APPLICATION NO.	FILING DATE	FIRST NAMED INVENTOR	ATTORNEY DOCKET NO.	CONFIRMATION NO.
10/588,579	02/01/2008	Mihai Adrian Tiberiu Sanduleanu	NL04 0105 US1	8721

Office Action Summary	Application No. 10/588,579	Applicant(s) SANDULEANU ET AL.	
	Examiner DANIEL ROJAS	Art Unit 2816

DETAILED ACTION

Figure 1: Kubota's gates 16, 17, and 18 at a transistor level

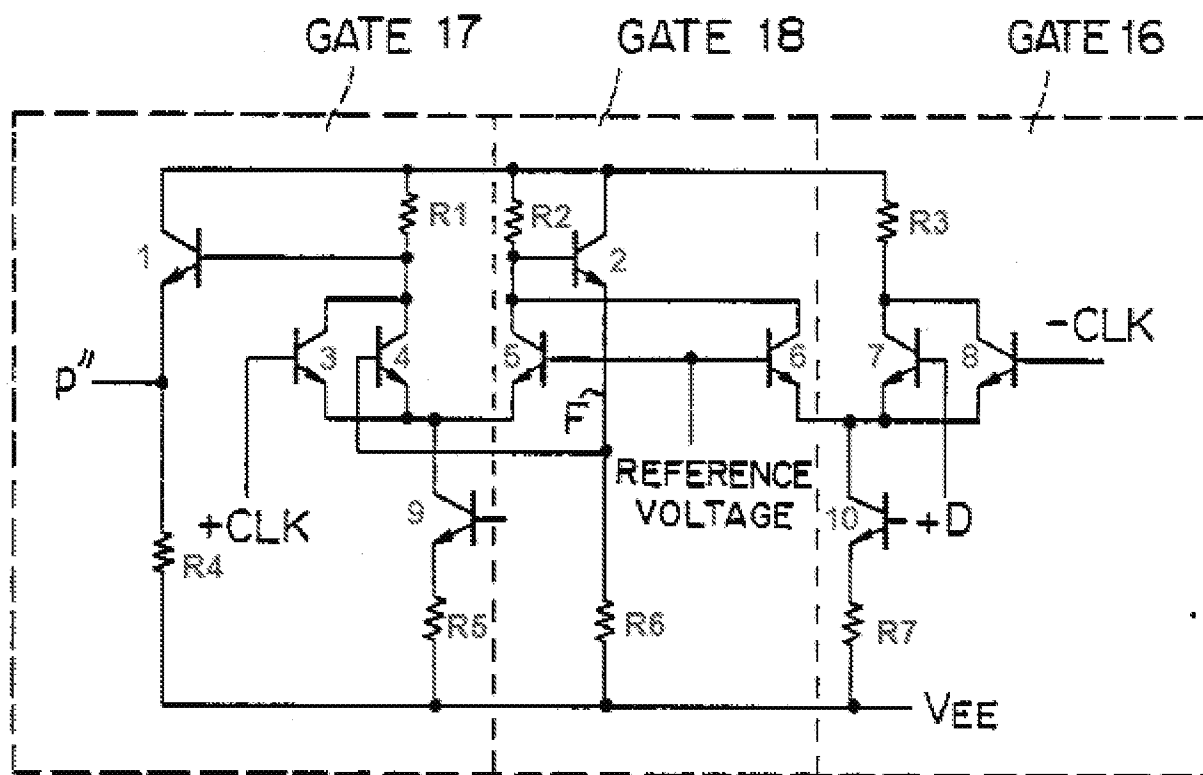
8. Claims 1-6 and 8-9 are rejected under 35 U.S.C. 103(a) as being unpatentable over Kubota (US Patent No. 4,841,168), hereinafter referred to as Kubota. Please refer to the figure below:

9. For claim 1, Kubota teaches in his Figure 5 (shown in detail in his Figure 8), a latch circuit comprising: a differential input with an inverting input (D input of 17) and a non-inverting input (input terminal of 16 connected to +D), one of the outputs (MASTER OUTPUT, which is a non-inverting output) being coupled to one of the inputs input (D-) having an opposite polarity, a control input for receiving a control signal (REFERENCE VOLTAGE, Figure 8) for determining a threshold for an input signal (D+, inherent in the structure of Figure 8) such that if the input signal is at larger than the threshold the non-inverting output in a HIGH logic state and in a LOW state if the input signal is smaller than the threshold (inherent based on the structure of Figure 8), respectively but fails to teach a differential output with an inverting output. However, examiner takes official notice that it is notoriously old and well known in the art to invert an output of a latch in order to change an active high output signal to an active low, for use with active low circuits. Therefore, it would have been obvious to one of ordinary skill in the art at the time of invention to branch off the MASTER OUTPUT signal into an inverter (i.e. a node from the MASTER OUTPUT signal being connected to the input of an inverter) in order to obtain an inverting output capable of use with active low circuits.

10. For claim 2, Kubota further teaches a latch circuit comprising transistors (as shown in Figure 8, with added numbering for reference in the figure above) the latch further comprising, a first pair of transistors comprising a first transistor (4) and a second transistor (5) having their sources coupled to each other (as shown), a second pair of transistors comprising a third transistor (6) and a fourth transistor (7) having their sources coupled to each other, a gate of the second transistor being coupled to a gate

of the third transistor (as shown) and further coupled to the control signal (REFERENCE VOLTAGE), a positive feedback from the non-inverting output (F) to a gate of the first transistor (as also shown in Kubota's Figure 5), a pair of switches comprising a first switch (3) and a second switch (8) having their respective drains and sources coupled to the respective drains and sources of the first transistor and the fourth transistor, respectively, but fails to teach that the gate of the first switch being driven by the inverting clock signal (-CLK, as explained below) and gate of the second switch being driven by the non-inverting clock signal (+CLK, as explained below). The terms "inverted" and "non-inverted" are used to describe the state of a signal (i.e. inverted or not inverted) in relation to a second signal. Therefore, since both -CLK and +CLK are clock signals, +CLK can be considered an inversion of -CLK. Examiner takes official notice that it is notoriously old and well known to replace bipolar junction transistors with MOS transistors. Therefore, it would have been obvious to one of ordinary skill in the art to replace Kubota's bipolar junction transistors with MOS transistors in order to reduce space, since MOS transistors can be manufactured much smaller than bipolar junction transistors.

11. For claim 3, Kubota further teaches that the sources of the first transistor and the second transistor are supplied by a first current source (9), the sources of the third transistor and the fourth transistor are supplied by a second current source (10).

13. For claim 5, Kubota further teaches that the drain of the first transistor and the drain of the fourth transistor are coupled to each other and further coupled to a supply voltage (VEE) via a first resistor means (R6).

14. For claim 6, Kubota further teaches that the drain of the second transistor (5) is coupled to a drain of the third transistor (6), the drains being further coupled to the supply voltage (V_{EE}) via a second resistor means (R2).

15. For claim 8, Kubota teaches a first current source (9), a second current source (10) which receive a reference signal via their respective gates and a third resistor means (R5 and R7) but fails to teach a series connection of a main current channel of a current source. It is notoriously old and well known that if multiple nodes are receiving a reference signal of equal voltage, the said multiple nodes can be connected to a single reference voltage source. Therefore, it would have been obvious to one of ordinary skill in the art at the time of invention to have Kubota's first and second current source (9 and 10, respectively) connected to the same reference voltage source since it has been held that discovering an optimum value of a result effective variable involves only routine skill in the art. In re Boesch, 617 F .2d 272, 205 USPQ 215 (CCPA 1980).

16. For claim 9, it is inherent for a transistor to be controlled by a voltage applied to its gate. Therefore, the first and second current sources (9 and 10, respectively) are controlled by a voltage.
